STATE OF NORTH CAROLINA  
DEPARTMENT OF TRANSPORTATION

January 20, 2011

**Subject: Request for Modification to Individual Section 404 and 401 permits, CAMA Major Development Permit, and Tar-Pamlico Riparian Buffer Authorization** for the proposed Washington Bypass. US 17 from North of SR 1509 (Springs Road) to North of SR 1418 (Roberson Road). TIP Number: R-2510C, Federal Aid Project MAF-75-3(26). Debit \$570 from WBS Element No. 34440.1.1.

The purpose of this document is to submit a modification to the final design and revised impact calculations to the Clean Water Act (CWA) Section 404 Individual Permit and Section 401 Water Quality Certification, Tar-Pam Riparian Buffer Authorization, and the CAMA Major Permit. Included in this application package are the following: revised permit drawings and buffer drawings.

PROJECT REFERENCE NO. R-2510C	SHEET NO. 5
R/W SHEET NO.	
ROADWAY DESIGN ENGINEER	HYDRAULICS ENGINEER
Permit Drawing Sheet 6 of 41 Revised

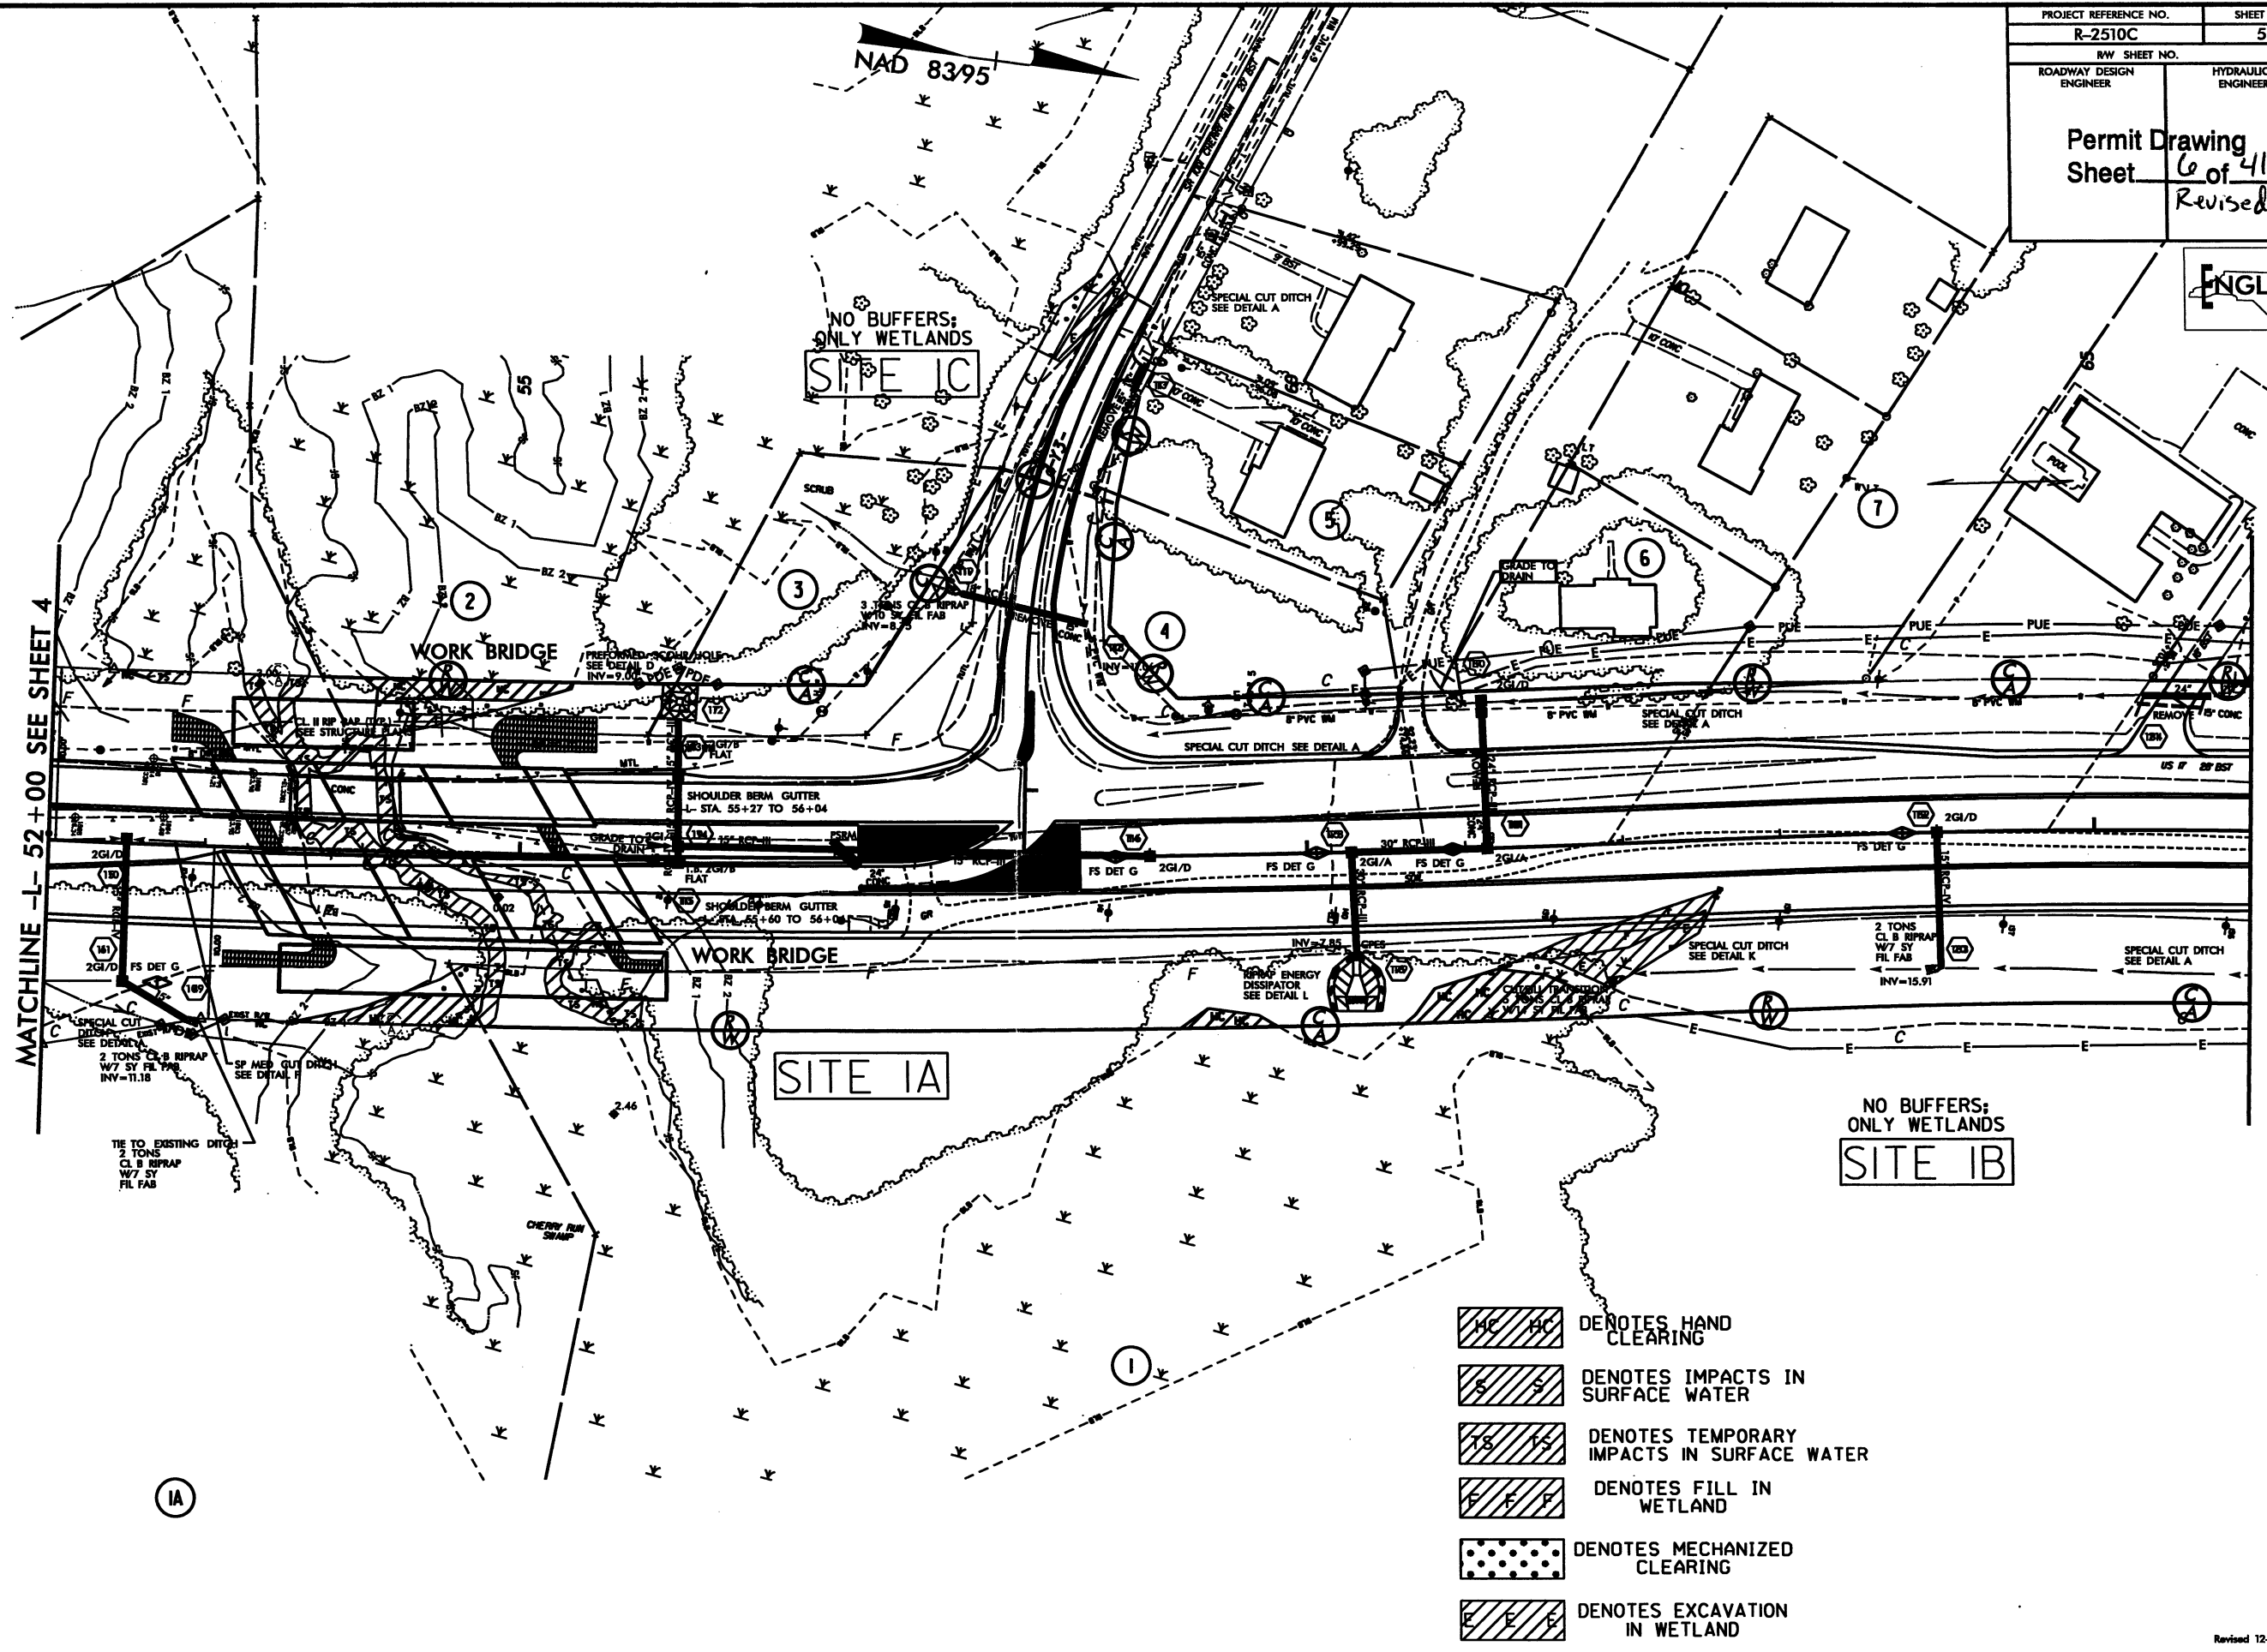
Due to utility construction at Sites 1A and 4C for wetlands and Site 1 for buffer, there will be an additional 0.08 acre of handclearing. Please replace the permit drawings with those included with this modification request.

PROJECT REFERENCE NO.	SHEET NO.
R-2510C	4
RW SHEET NO.	
ROADWAY DESIGN ENGINEER	HYDRAULICS ENGINEER
Buffer Drawing Sheet <u>7A</u> of <u>35</u> Revised

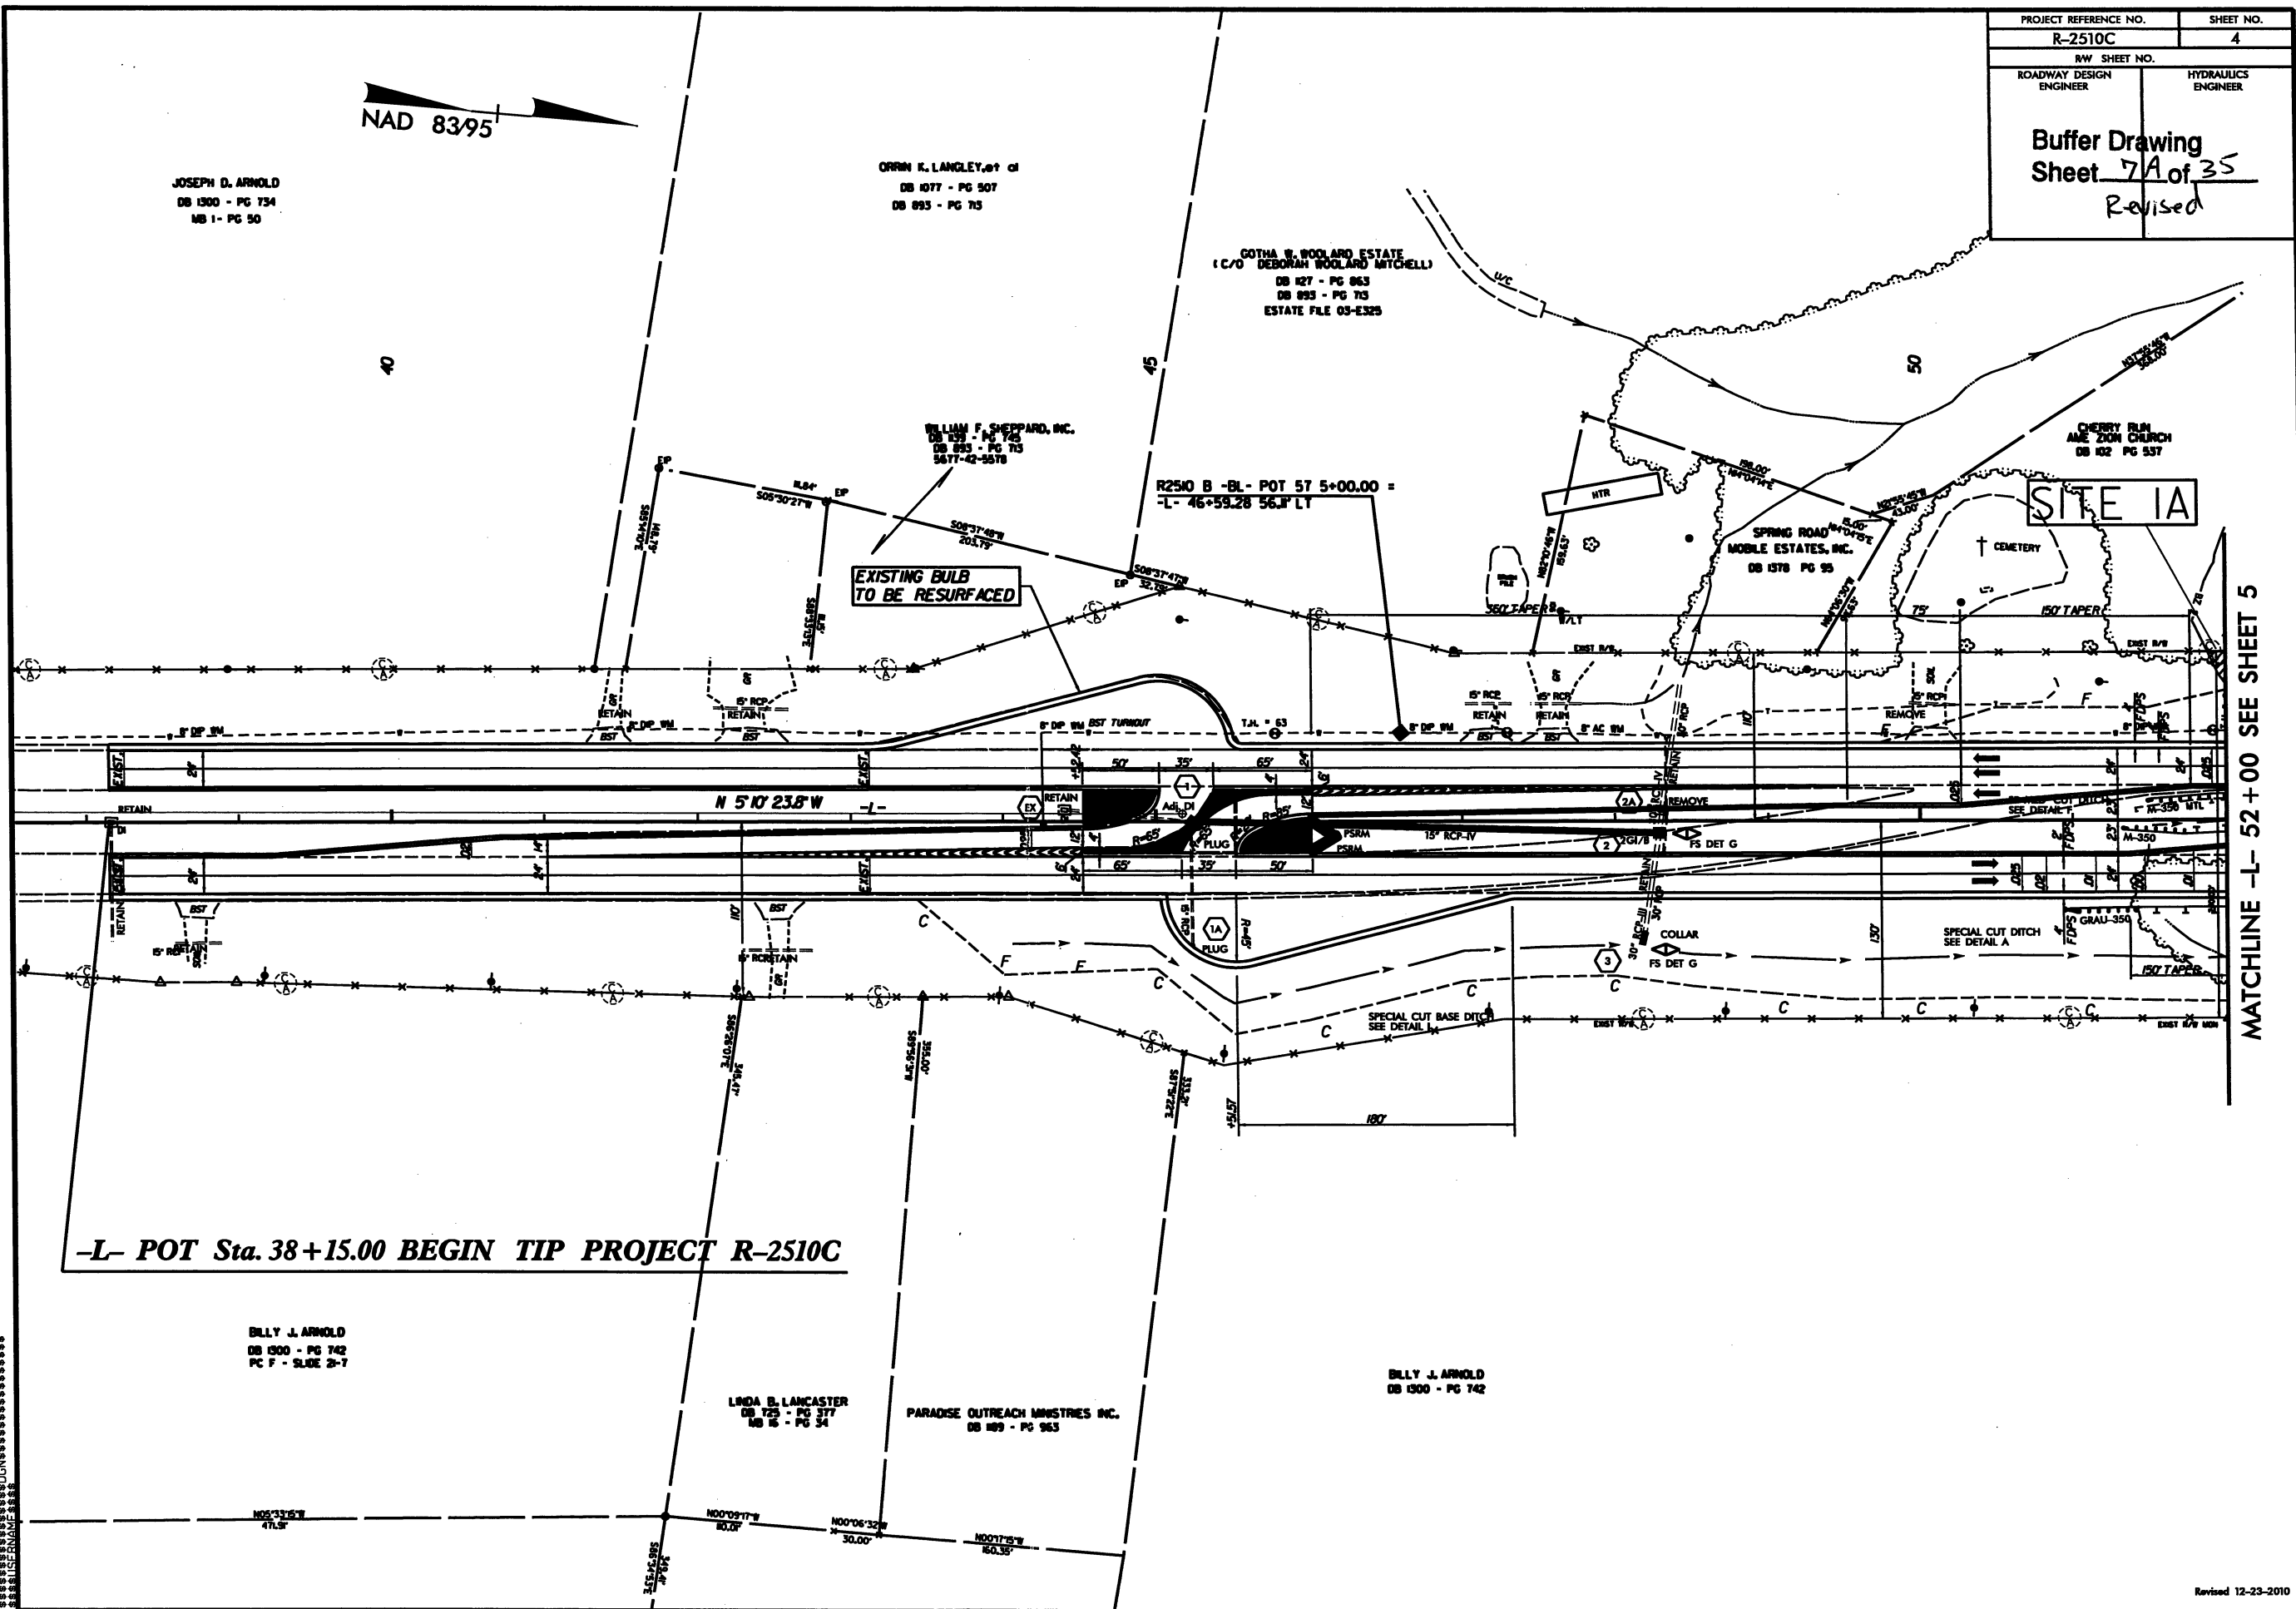
Buffers impacted due to this modification are 631 ft<sup>2</sup>: 279 in Zone 1 and 352 in Zone 2. These impacts are allowable.
